SPECIAL INSTRUCTIONS FOR 2000-2006 SOFTAIL 2001-2005 DYNA 2001-2006 FLT

For 2000 Softail and 2001 FLT/Dyna models, H-D upgraded the shift system to a roller detent configuration for smoother shifts. H-D also revised the ratchet pawl.

Illustration shown as viewed from the right side of the case, with the gearset removed.

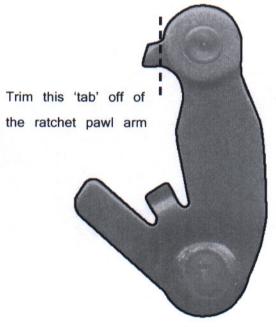
The new style ratchet pawl must be modified as shown below to be compatible with the Baker Six-Speed Overdrive shift drum.

To accomplish this, we recommend that the ratchet pawl be removed from the transmission case. Remove the spring-loaded pawl from the arm to gain clear access to the "beak" on the arm. Remove the material, as shown below, with a bench grinder.

Reassemble the ratchet pawl and continue with the installation process per the Builder's Kit Installation Instructions.
